**RE: PUCO Case No. 19-1068-EL-BTA  
Amendment to Barnesville-Summerfield 138kV Transmission Line Rebuild  
Project  
Request to Withdrawal Shift 2**

## AMENDMENT CHANGE SUMMARY

### Exhibit 1: Summary of the Changes to the Preferred Route

**Reroute****Exhibit 14: Reroute 1**

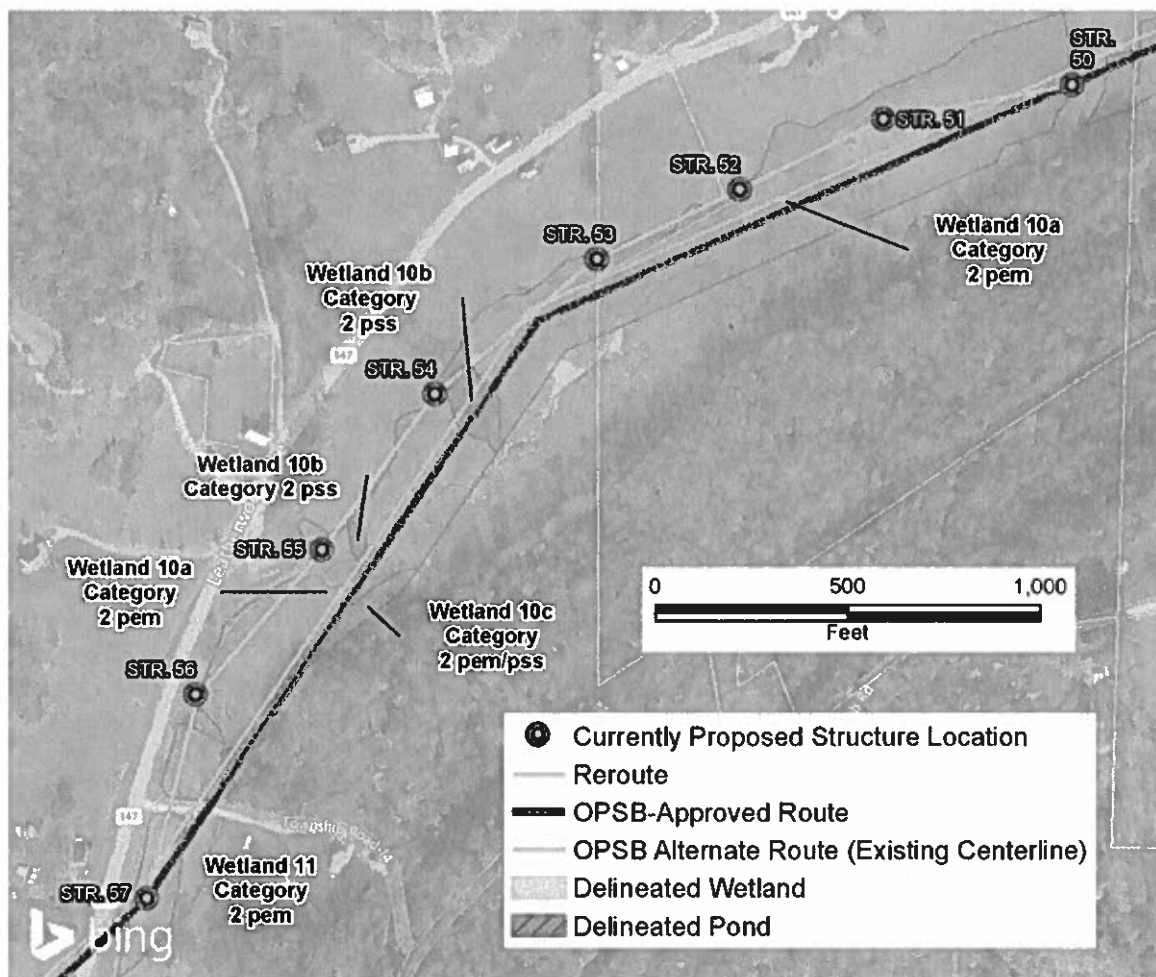
One reroute of the OPSB-approved route between Structures 50 and 57 was necessary to reduce wetland impacts while continuing to accommodate property owners. AEP Ohio Transco negotiated the placement of the centerline at the edge of the wetland with most poles placed in upland areas. The centerline was shifted to decrease the amount of disturbance to the wetlands. Wetlands 10a, 10b, and 10c are an ORAM Category 2 complex with palustrine emergent (PEM) and palustrine scrub/shrub (PSS) components. Wetland 11 is classified as ORAM Category 2, PEM. No additional environmental (including tree clearing) or landowner impacts are expected due to Reroute 1.
